From: Rossi, Steph @ Sydney <Steph.Rossi@cbre.com>
Sent: Thursday, 27 January 2022 10:58 AM
To: Alejandra Rojas <Alejandra.Rojas1@det.nsw.edu.au>
Cc: Spedding, Stephen @ Sydney <stephen.spedding@cbre.com.au>; Carmody, Greg @ Sydney <Greg.Carmody@cbre.com>; Jack Bruderlin (Jack Bruderlin) <Jack.Bruderlin@det.nsw.edu.au>; Lawler, Nicholas @ Sydney <Nicholas.Lawler@cbre.com>; Chris McGillick <CMcGillick@ethosurban.com>; Ella Coleman <EColeman@ethosurban.com>
Subject: RE: RFI - DPIE further comments

1. *The Department previously requested details of internal layout of Childcare Centre and internal play spaces. This information has not been provided. Please submit amended plans with the internal layout with test fit concept plan to demonstrate compliance with the required play area for 40 preschool children.*

NEW LIVERPOOL PRIMARY SCHOOL

DRAWING TITLE
UNENCUMBERED PLAY & TREE CANOPY

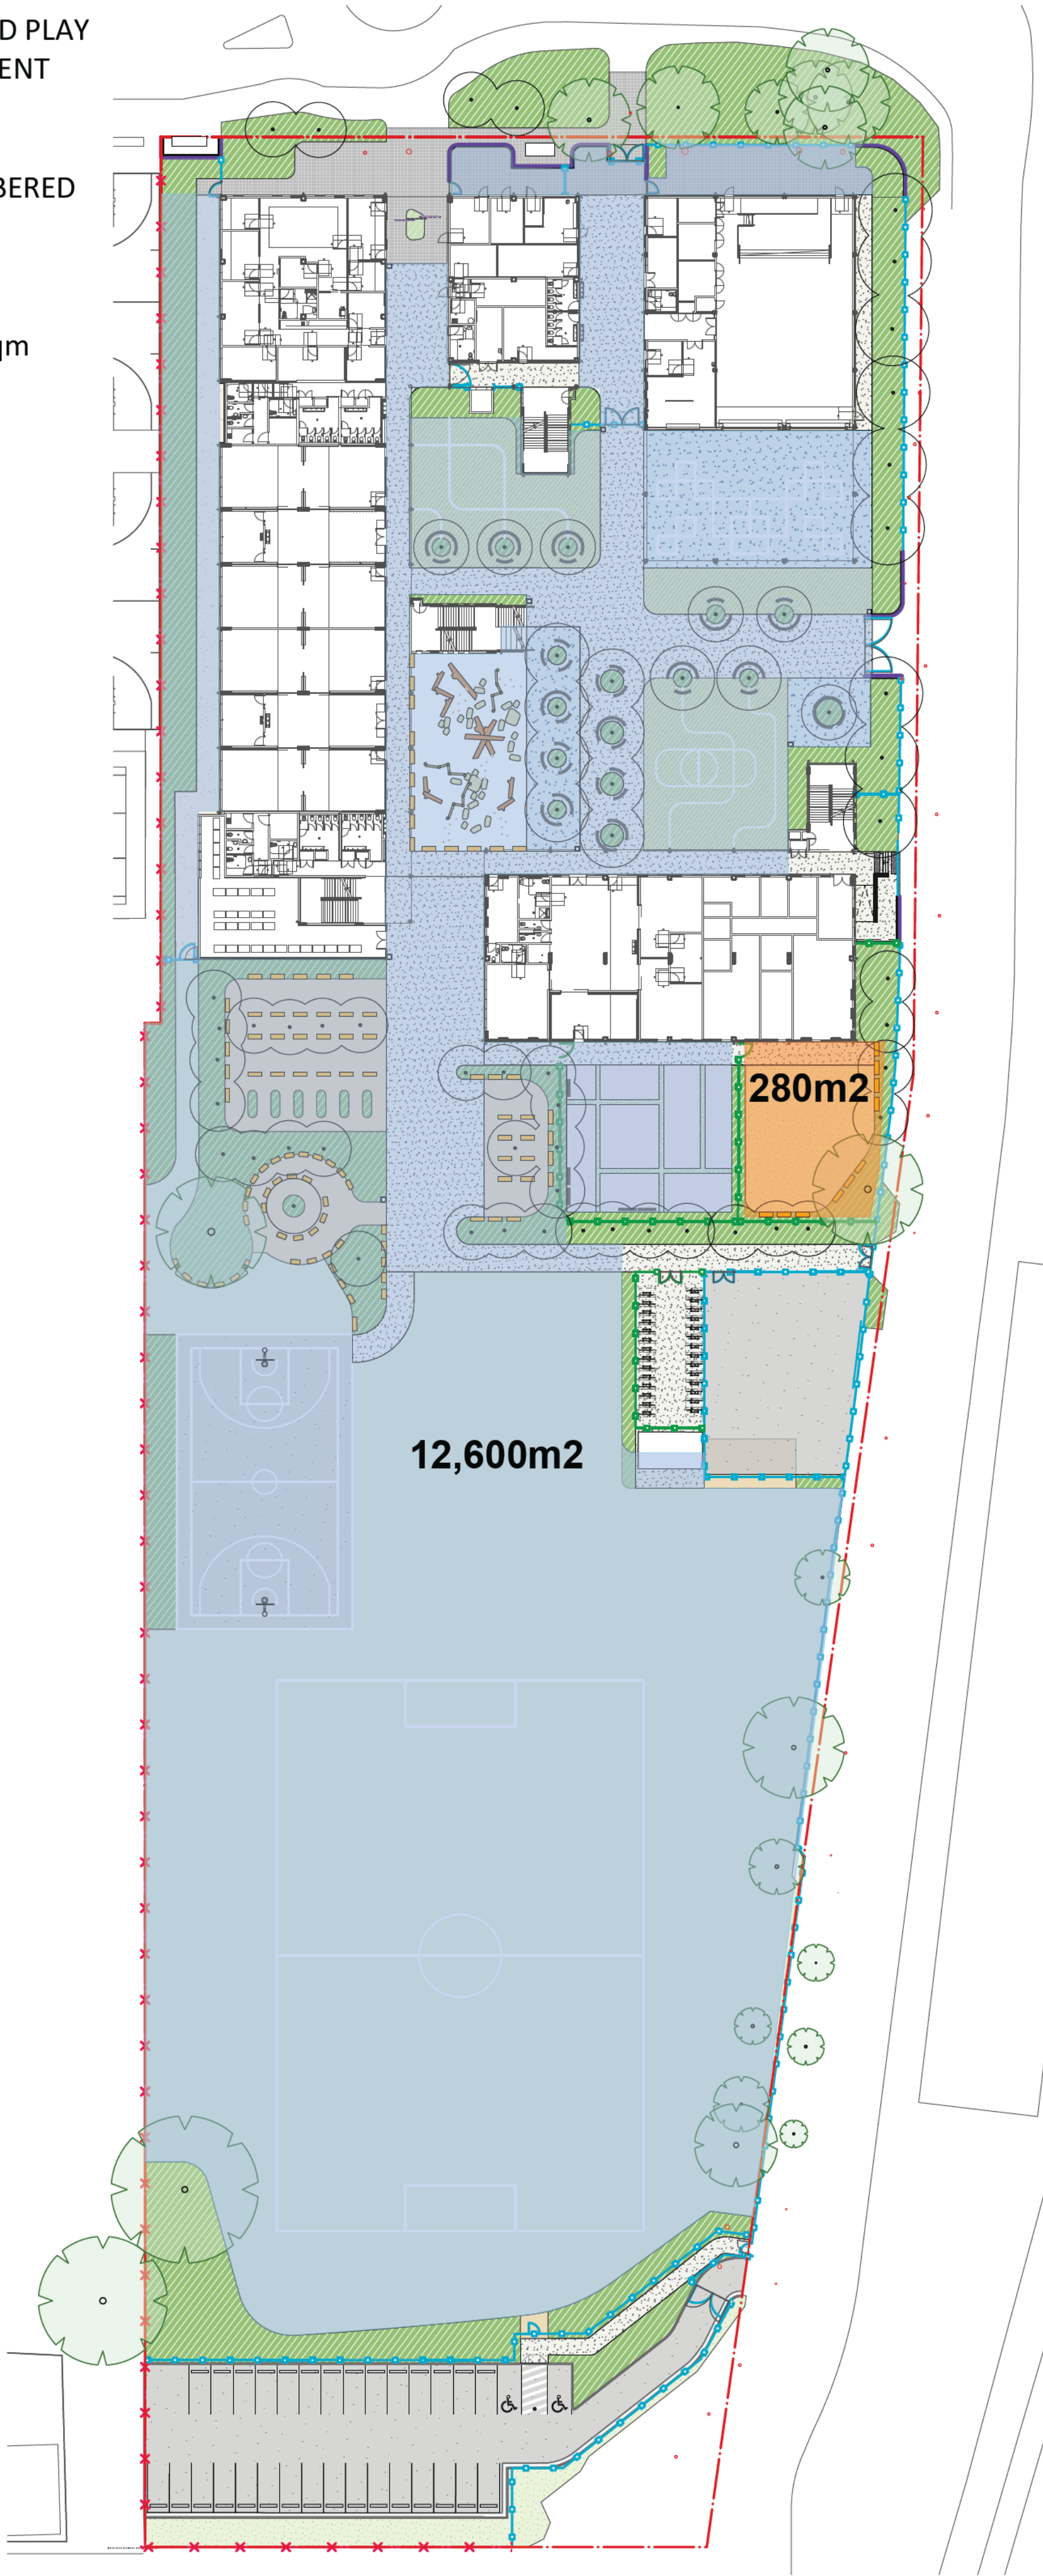
2. *The submitted drawing no NLPS-AR-DRG-0203 showing unencumbered play area for childcare centre in a narrow strip and the drawing no NLPS-LA-SSD-3600-DRG showing the trees planting/landscaping on the play area. The narrow strip is not suitable for play for the children. Amended drawings are required to show the proposed/future childcare centre complies with the State Environmental Planning Policy (Educational Establishments and Child Care Facilities) 2017 (Education SEPP) and the Department's guidelines.*

- *the details of the proposed percentage of tree canopy cover should be provided. The proposal should target a 40% canopy cover, particularly due to the hot and dry context to help reduce temperatures. To meet the canopy target, the oval should be bordered with appropriately selected trees to create shade for spectators. The amended architectural drawings and submitted documents says only 26% mature canopy cover is provided. The proposed development does not demonstrate alternative way to minimise temperature during hot and dry seasons. Therefore you are requested to amend the landscape drawing to increase canopy cover.*

Refer to **ATTACHMENT B**, showing the amended play area excluding the narrow landscaped zone, achieving the required play area for the future preschool.

The Project will accept a condition of consent, however, please refer to attached drawing at **ATTACHMENT B** which shows initial and mature tree coverage calculations.

Drawing Title
SITE PLAN - SOUTHERN PART

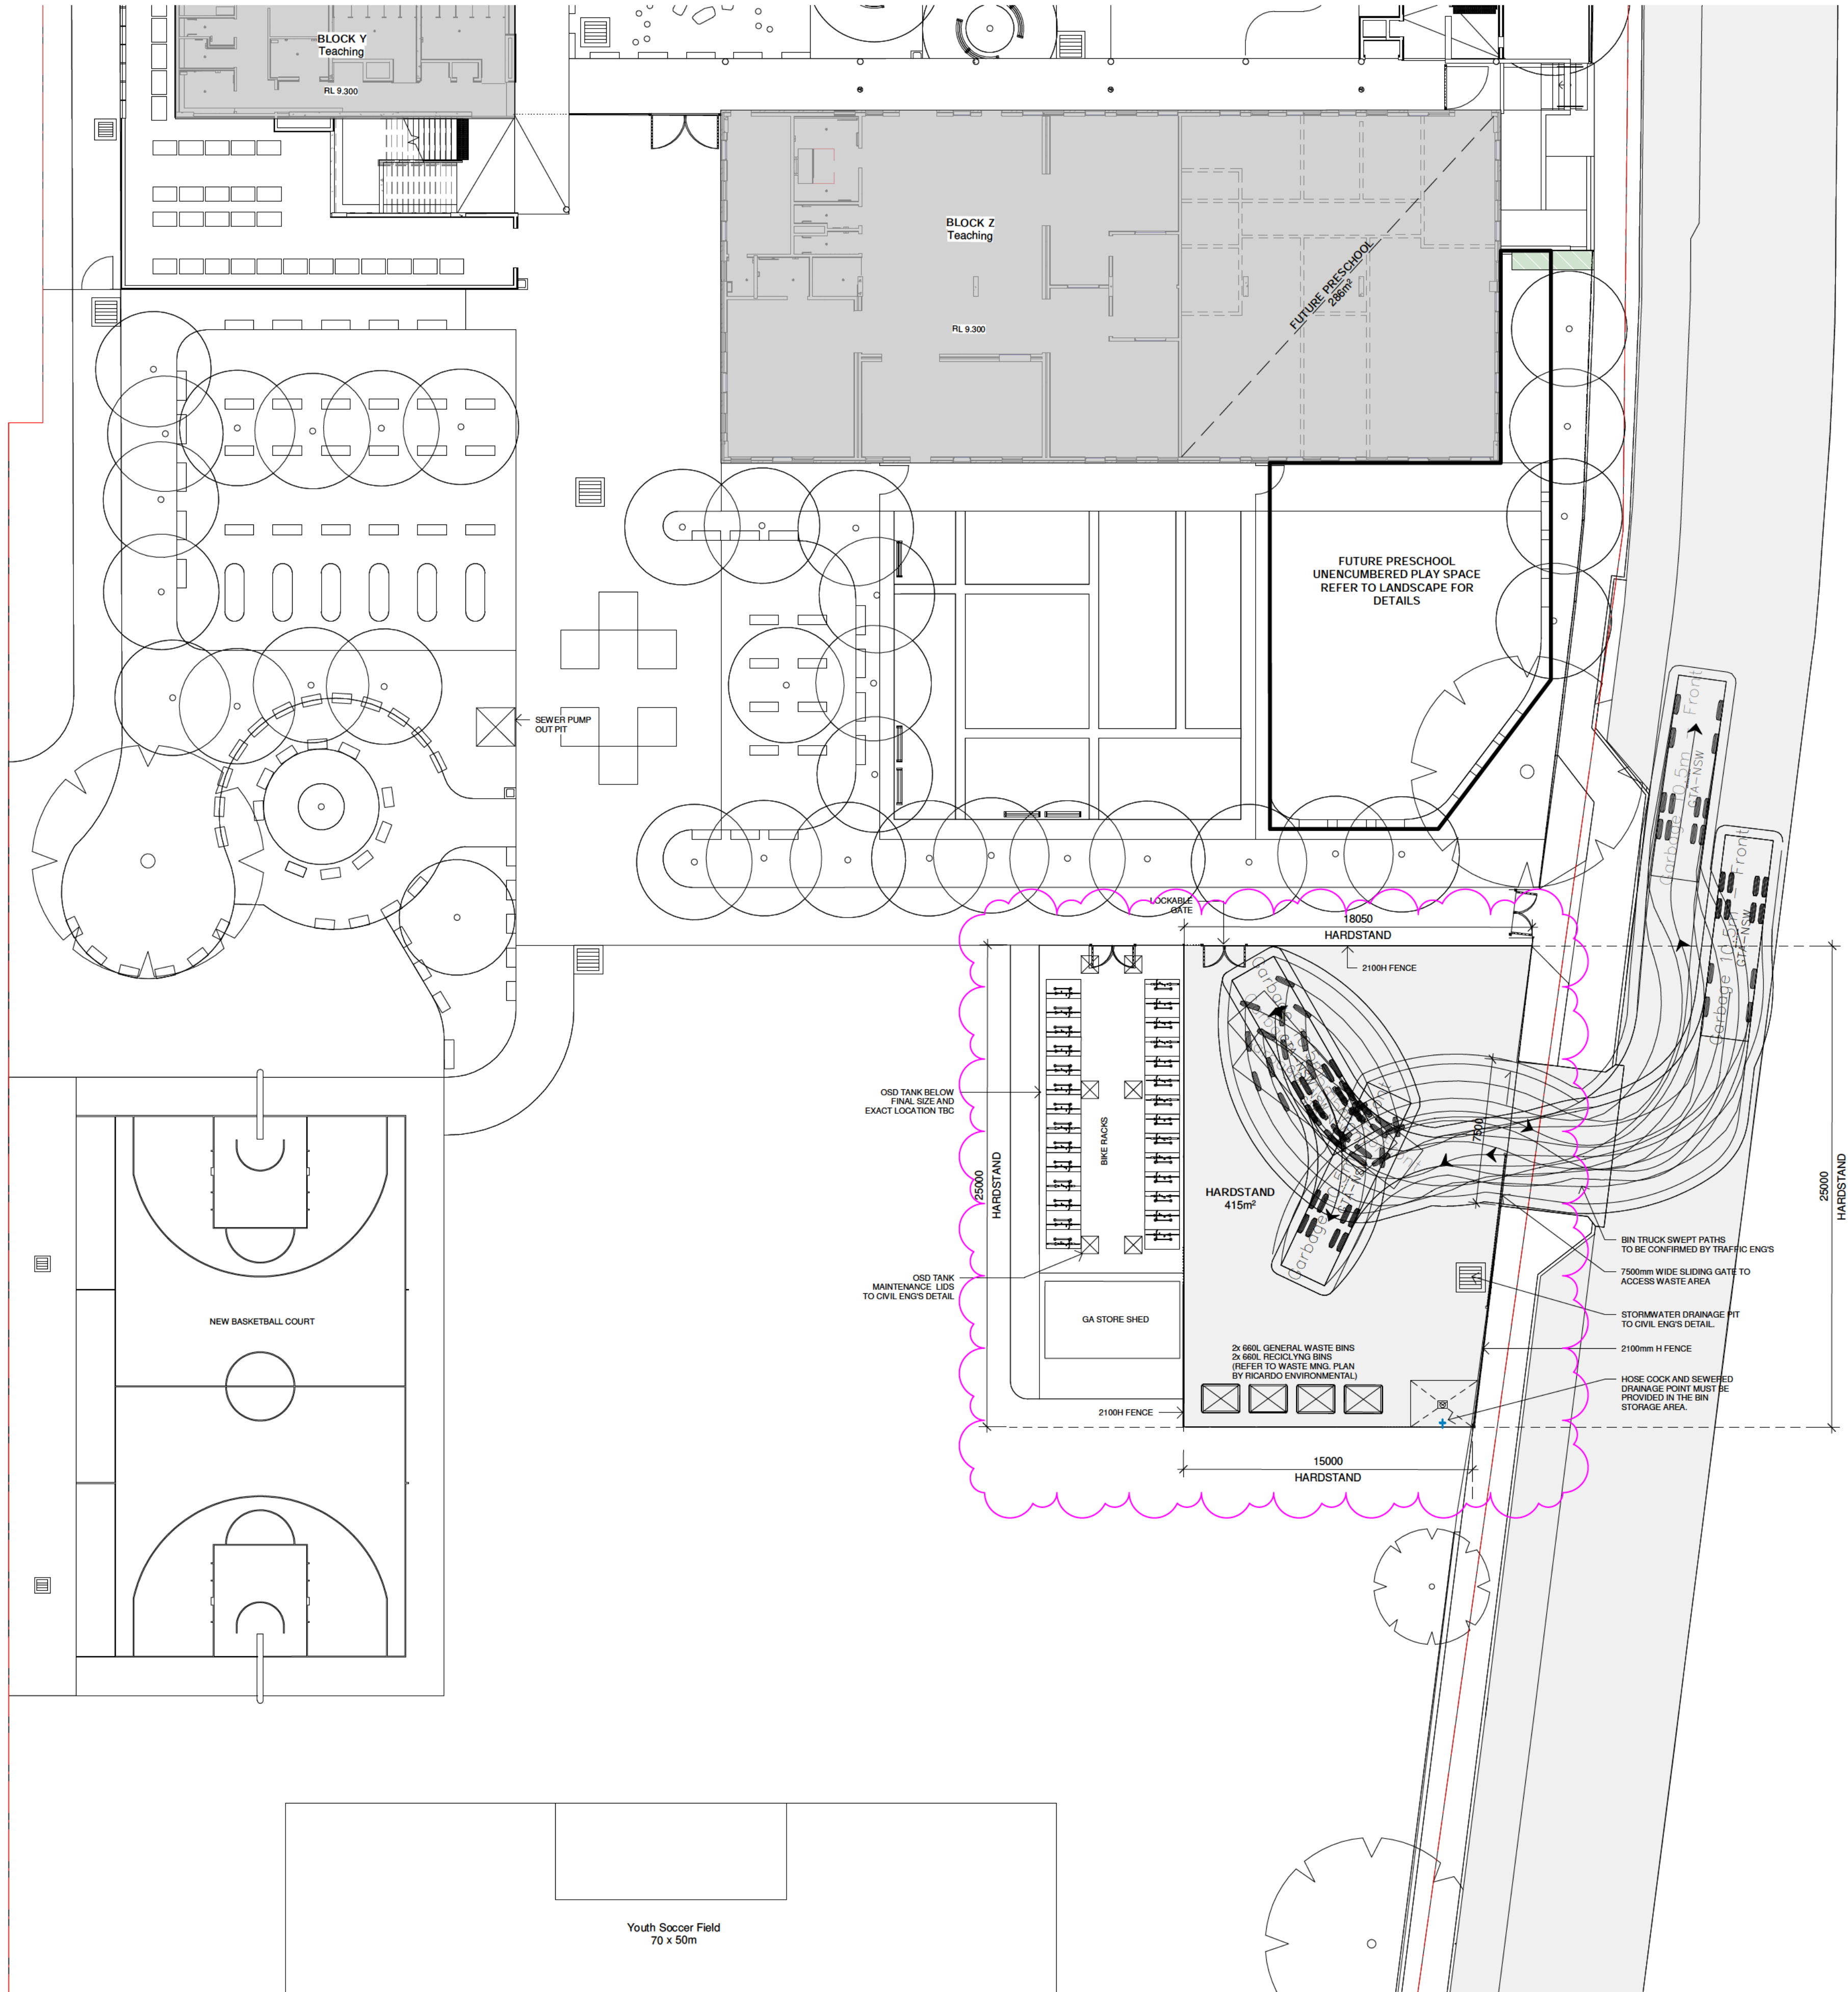
3. *The submitted drawing no NLPS-AR-DRG-0203 shows the manoeuvring of MRV vehicle's turning path. The Department notes that the allocated hardstand space is not sufficient for MRV manoeuvring and that the MRV would encroach into the waste area. Please address this issue and relocate/resize the hardstand area or relocate the vehicle turning circle area to allow for adequate manoeuvring of MRV within the site.*

7. *The areas and dimension for waste storage should be shown on the architectural plans. The dimensions and area have not been shown clearly.*

Refer to **ATTACHMENT C**. The bin storage area and surroundings have been reconfigured to show the bins to the south of the hardstand and therefore provide increased manoeuvrability for a medium rigid vehicle. The bins and bin wash area have been shown on the plan in accordance with the requirements of the Waste Management Plan.

As typical of SINSW schools, the strategy for this school is that waste is removed from classrooms and other building areas by the cleaners and transported directly to the external waste area for collection by an MRV. Hard paved surfaces have been provided along the route from the building to the waste area to enable easy movement of the cleaners’ waste trolley. Refer to **ATTACHMENT C** for revised layout of the waste area.

CONNECTION TO COUNTRY
OPPORTUNITIES

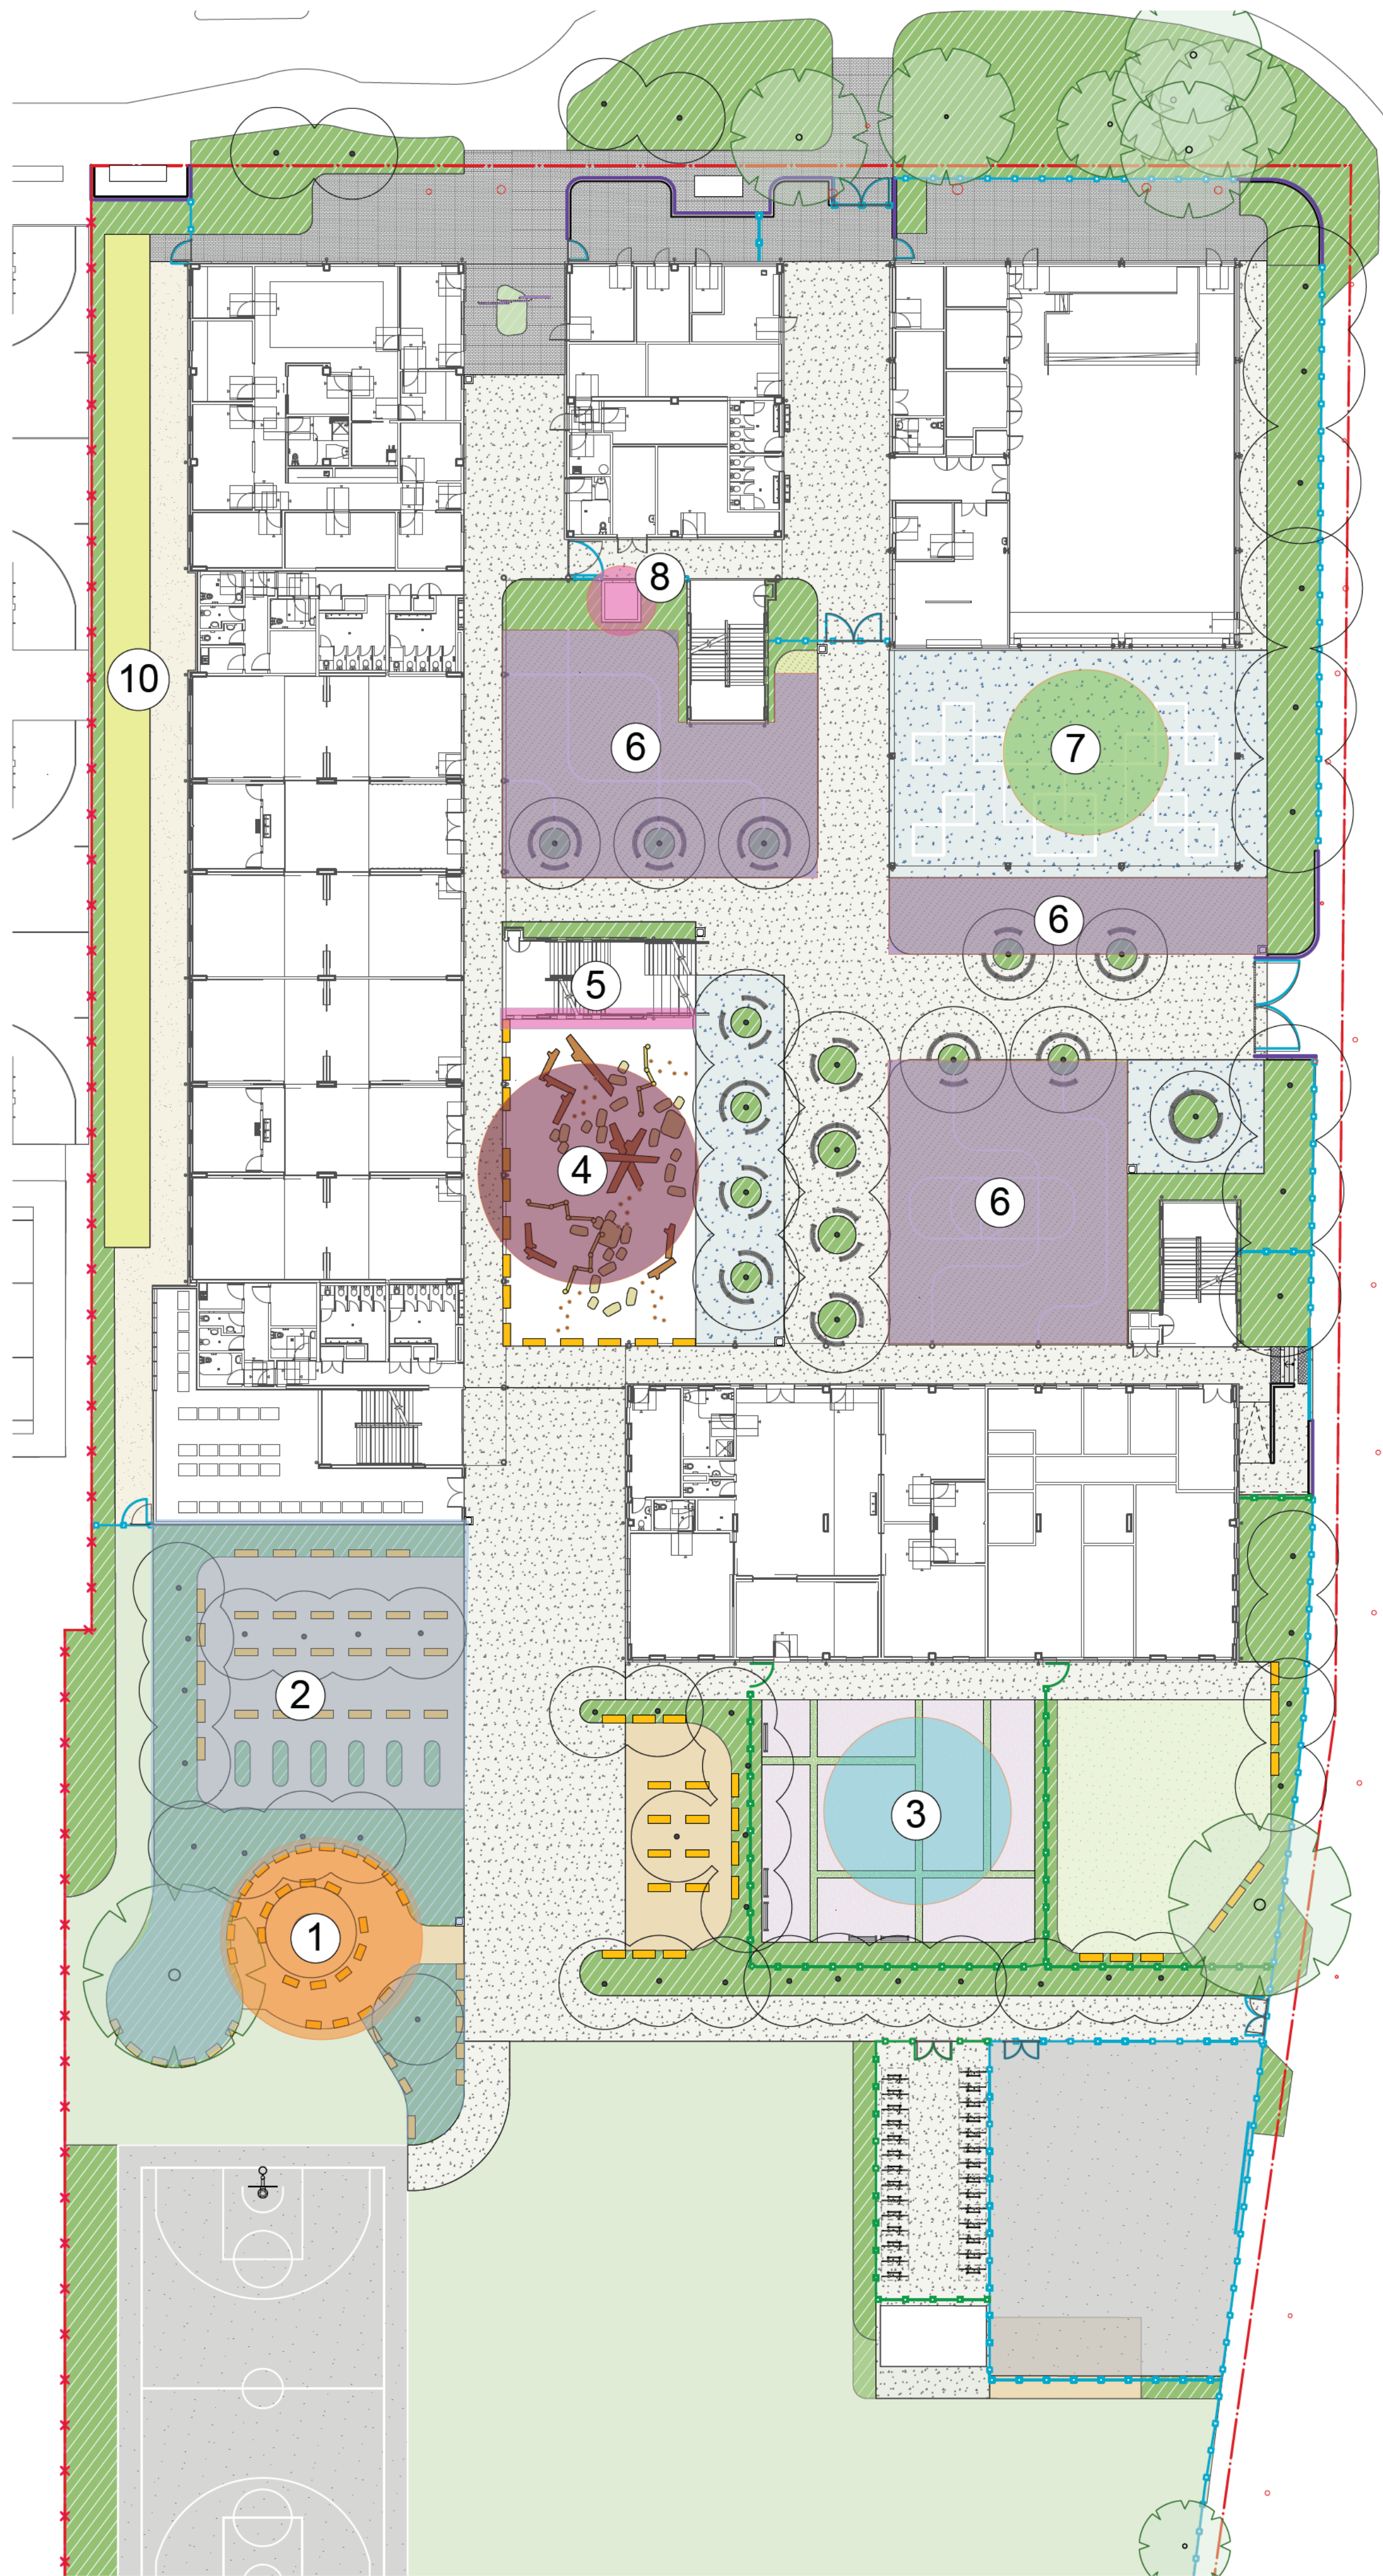
- *Submitted strategy report ‘Connection to Country’ does not demonstrate any date of engagement and how the engagement will be influenced holistically. The Secretary’s Environmental Assessment Requirements (SEARs) required the application to demonstrate that Aboriginal culture and heritage has been considered and incorporated holistically in the design.*

Refer to the revised Connecting with Country Strategy at **ATTACHMENT D** with additional details including proposed dates of engagement opportunities and details of engagement undertaken to date. Refer to the plan at **ATTACHMENT E** which has been provided by the architects illustrating opportunities for specific Aboriginal elements to be incorporated into the design during the detailed consultation and future design phases.
